172/174/182/195
UNITED STATES
NUCLEAR REGULATORY COMMISSION
WASHINGTON, D.C. 20555-0001

SUBJECT: POINT BEACH NUCLEAR PLANT, UNIT NOS. 1 AND 2 - REQUEST
FOR ADDITIONAL INFORMATION RE: TECHNICAL SPECIFICATION
CHANGE REQUESTS RELATING TO RADIATION PROTECTION
(TAC NOS. M92346/7, M95350/1, M96261/2, AND M97839/40)

REQUEST FOR ADDITIONAL INFORMATION

RESPONSES TO QUESTIONS CONTAINED IN THE
REQUEST FOR ADDITIONAL INFORMATION (RAI)
ON POINT BEACH 1 AND 2 REQUEST
FOR DISPOSAL OF LOW LEVEL RADIOACTIVITY
CONTAMINATED SEWAGE SLUDGE BY LAND APPLICATION
WISCONSIN ELECTRIC POWER COMPANY
UNDER 10 CFR 20.302(a)

FIGURE 3

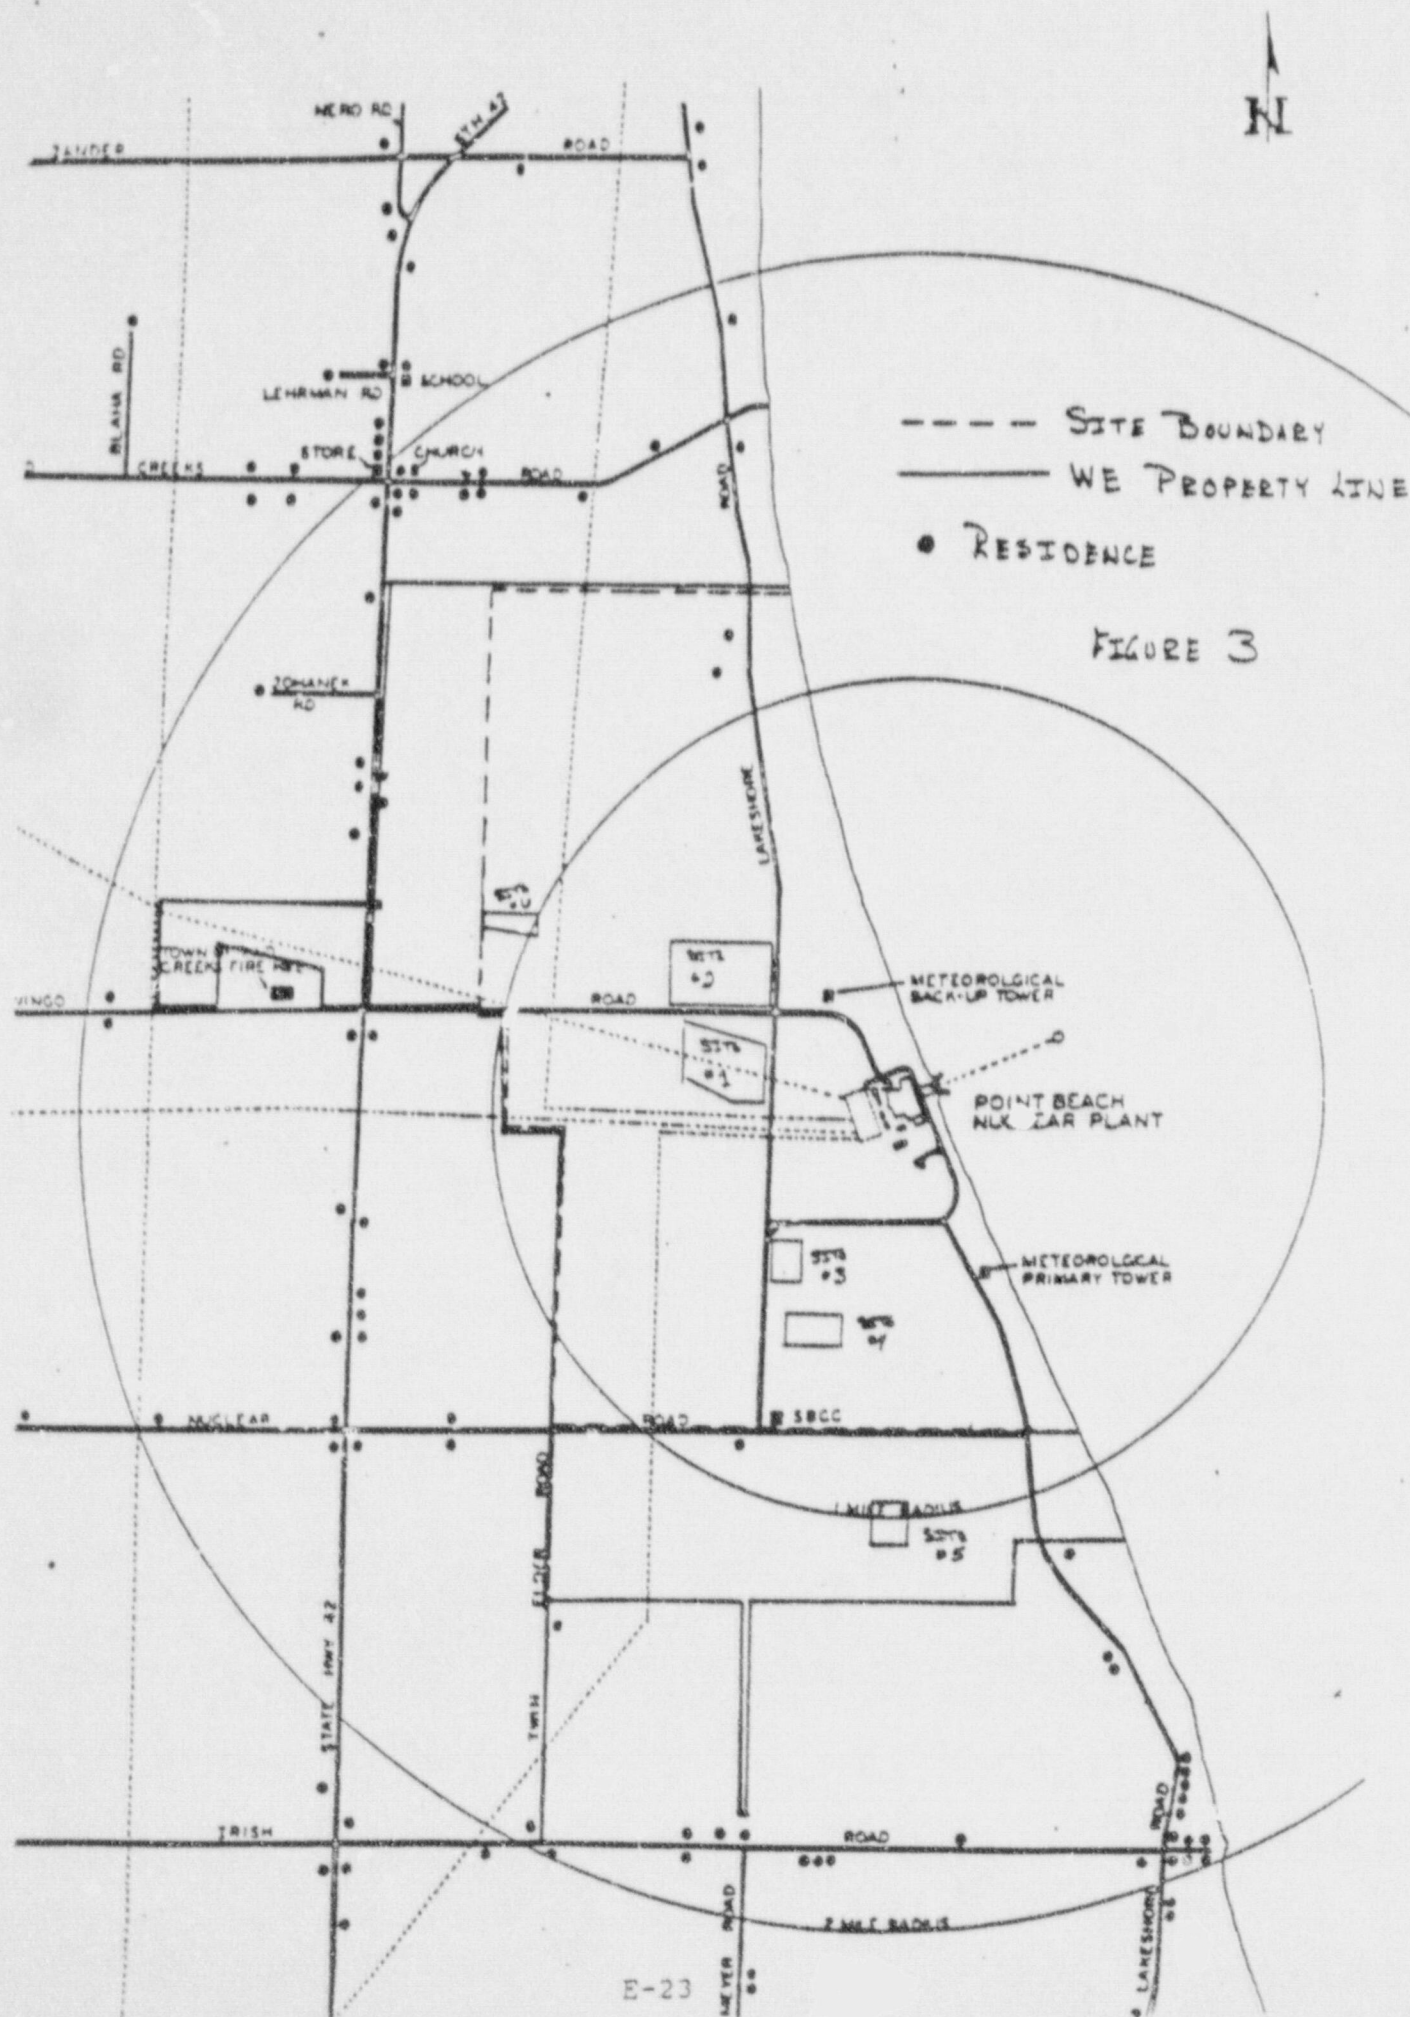
3. Information contained in previous submittals has been included in Attachment II with modifications to provide specific commitments to the NRC.
4. Please refer to the response to question number 10.
5. Site maps have been updated and are included in Attachment II, Appendix C.
6. The direct grazing of cattle on the proposed disposal sites is controlled by restrictions contained in the lease agreement.

7. Please refer to revised site maps included in Attachment II, Appendix C. Site number 5 is located on company owned land beyond the PBNP site boundary. All other sites are within the PBNP site boundary area.

1. The site map in Appendix C, Figure 3 details the spatial relationship between the proposed disposal sites and the local ground water wells. The flow gradient of ground water was determined for the PBNP FSAR to be towards Lake Michigan. Reviewing the sites and local wells shows no private well located in the path of radionuclide migration towards Lake Michigan.
